ANN ARBOR HISTORIC DISTRICT COMMISSION

Staff Report

ADDRESS: 212, 214, and 216 East Washington Ave., Application Number HDC 13-082

REPORT DATE: June 7, 2013

Comb. Photo - North Existing Conditions

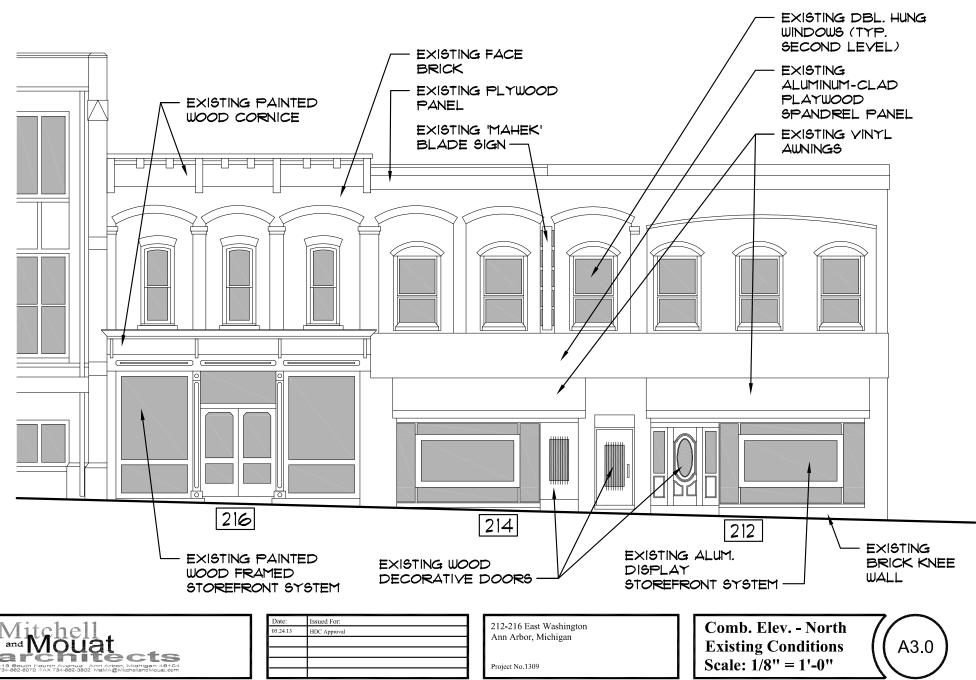
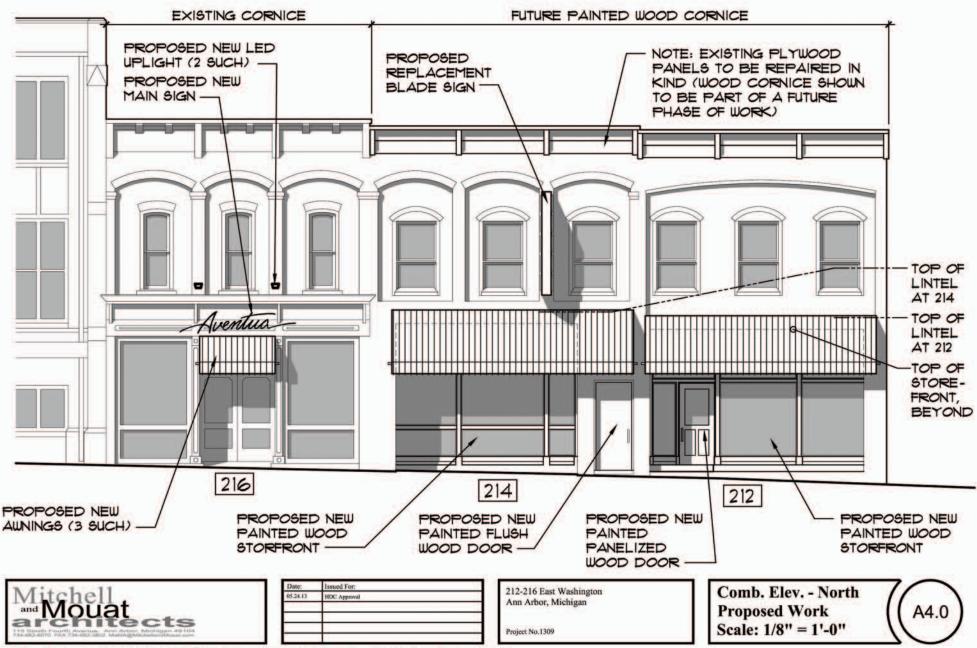
1. The storefronts on 212 and 214 most recently housed Mahek Indian restaurant. The storefronts, doors, and second floor windows are not original. The storefront on 216 is a reproduction of the original. 214's storefront would be recessed 4'5", as would the entry door to 212. The 212 storefront would be flush with the building façade. The storefront windows would extend all the way to the steel lintel beam shown in the 1942 photos

(sheet A1.0) once the aluminum and plywood spandrel panel and underlying wood infill is removed.

212 Photo - West Proposed Work

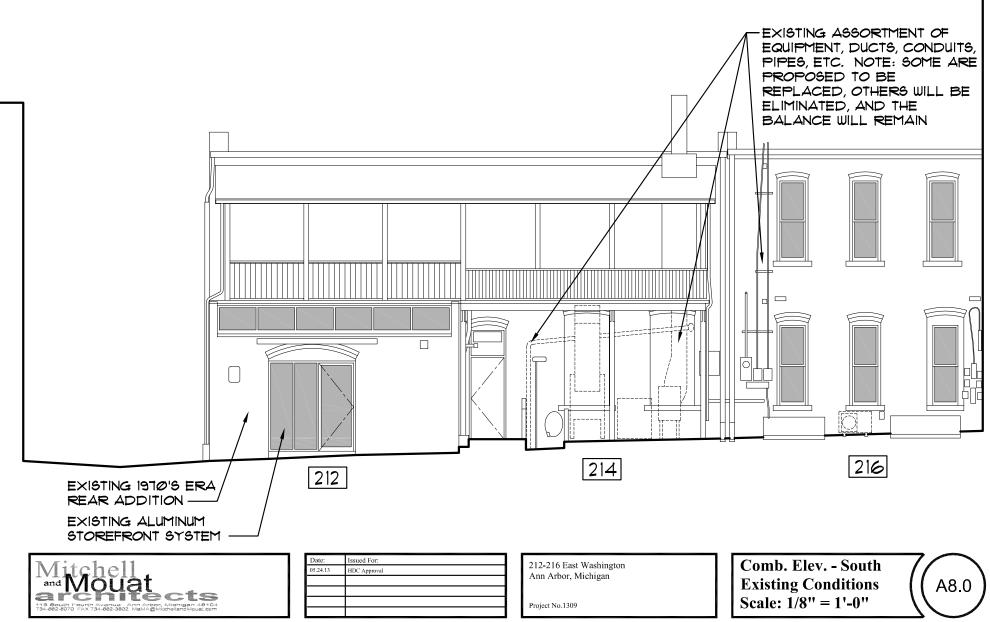
- 8. A third sign is shown on 212 on sheet A5.0. An existing small "Mahek Indian Cuisine" sign is proposed to be replaced, though with what is not specified. This will require a staff approval at a later date.

- 9. A mural is also shown on A5.0. The west wall of 212, facing the alley, has a large area of white paint where graffiti was covered over. The application proposes a mural in this area. Since most of the proposed area is already painted brick, staff recommends

approval. The design of the mural is unspecified, but since paint is reversible, staff is in support of a future mural as long as it does not extend beyond the area shown on the application. This work would also enliven the alley, which is likely to have more pedestrian traffic as a result of the restaurant proposing seating behind the 216 building.

Proposed Signage - Aventura

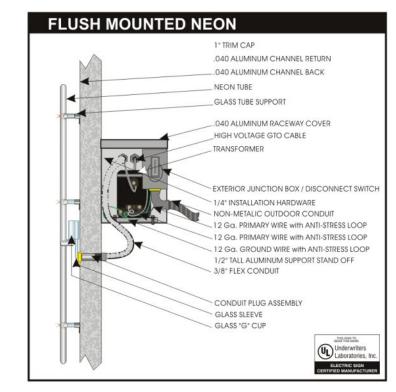
- 6. Two signs are shown on the drawings. A blade sign in the same location and length as an existing sign is located on the second floor. No detail is provided; if the sign meets the *Ann Arbor Historic District Design Guidelines*, a staff approval can be issued at a later date. A white, skeletal neon sign "Aventura" is proposed on the cornice of 216. No dimensions are given for the sign, though it fits between the decorative brackets of the storefront cornice.

- 7. The *Historic District Design Guidelines* are silent about the use of neon for signs. Staff generally recommends that neon be used only as an accent on blade signs because of its intensity. On this building, however, the skeletal neon design is appropriate because it doesn't obscure the detailing of the wooden cornice the way a traditional signboard would. The night simulation indicates that the intensity of the light is minimal the neon will glow, but its light is not strong enough to cause the cornice brackets to cast a shadow. The location just above the storefront is appropriate.
